Re: Item PG18.5 – Proposed Technical Amendments to By-law 569-2013

RE: Amendments to By-law 569-2013 (Section 200.15)

Proposed Adjustments to Accessible Parking Spaces
Submitted to the Planning & Growth Management Committee

Drawing No. Figures 1 - 6

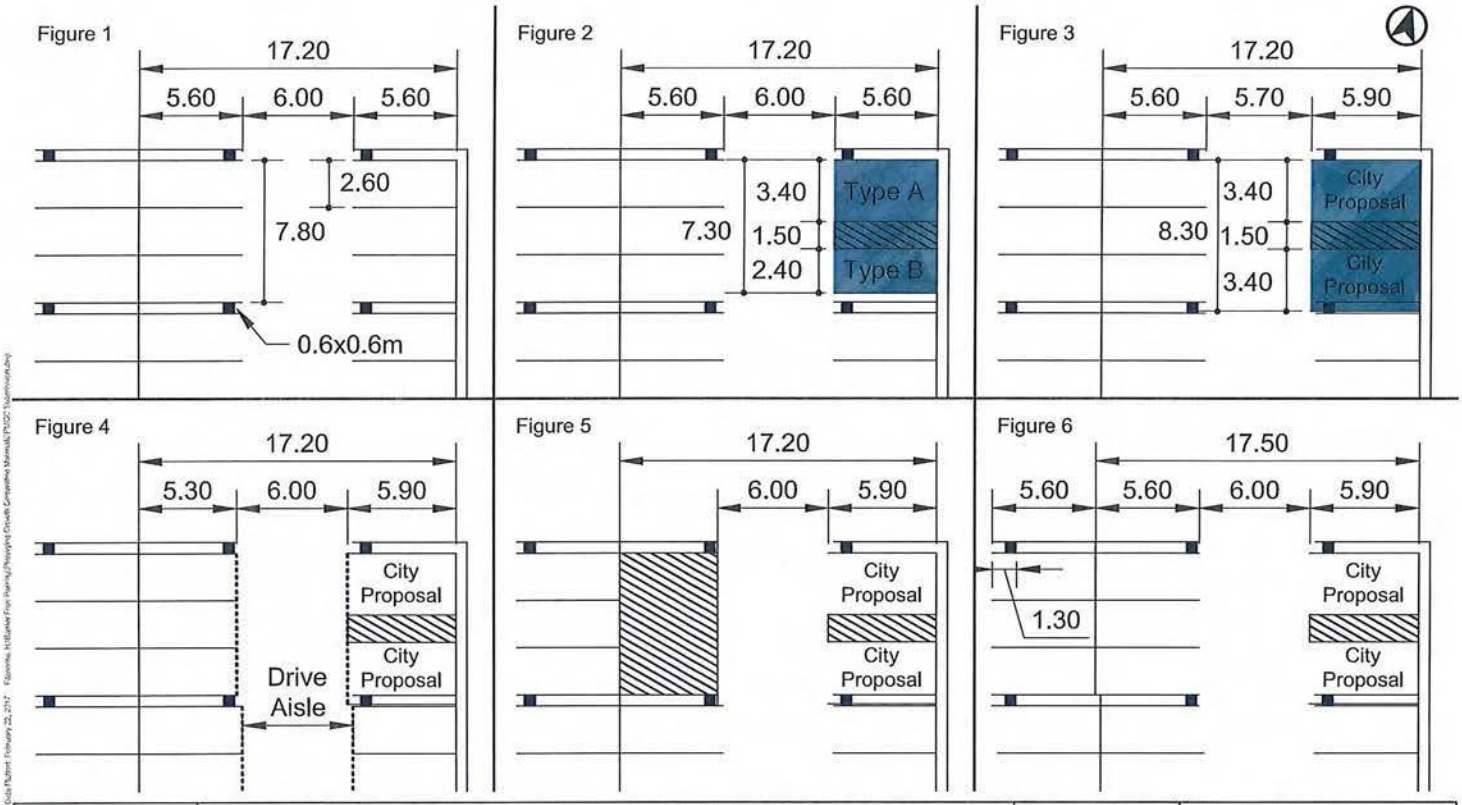
The impact to development of the proposed change is significant. The current width of 3 City of Toronto parking spaces (the typical number of spaces that fit within a typical structural grid in an above- or below-grade parking structure) is 7.8m plus the width of adjacent columns (Figure 1). Three typical spaces can be replaced with 2 AODA-compliant accessible parking spaces (3.4m "Type A" + 1.5m aisle + 2.4m "Type B" = 7.3m, Figure 2). Replacing 3 typical spaces with 2 proposal-compliant accessible spaces results in a required width of 8.3m (Figure 3). This exceeds the typical structural grid used in above- or below-grade parking facilities and may require structural changes near accessible spaces.

However, there are significant impacts to structured and surface parking facilities by lengthening accessible spaces to 5.9m from 5.6m. An additional 0.3m would require that typical parking spaces opposite the accessible spaces (those on the other side of the drive aisle) would need to be moved to permit the 6.0m drive aisle required under the bylaw. This has three unintended impacts.

1) Drivers, travelling down the drive aisle, would see the 6.0m aisle "jog" to the side as they travelled, resulting in a less safe condition within the parking area (Figure 4).
2) Parking spaces opposite the barrier free spaces may become shorter (5.3m in length) which would require by-law relief (Figure 4). Without relief all parking spaces within the impacted zone would be forced to shift (with parking spaces also shifting the entirety of the parking area) or resulting in the creation of unusable space within the parking area (Figure 5).
3) If structural grids could not be adjusted to accommodate the shifts required by the longer spaces, some parking spaces might violate the City's "obstruction rule" within the By-law (200.5.1.10 (D)), resulting in the need to seek relief from the rule through a variance or Site Specific By-law (Figure 6).

Our recommendation would be to adopt the sharing rules (between Type A and Type B spaces) as set out in the AODA and to adjust the length requirement to 5.6m so as to be compliant with the AODA and to be compatible with other critical zoning by-law parking dimensions.
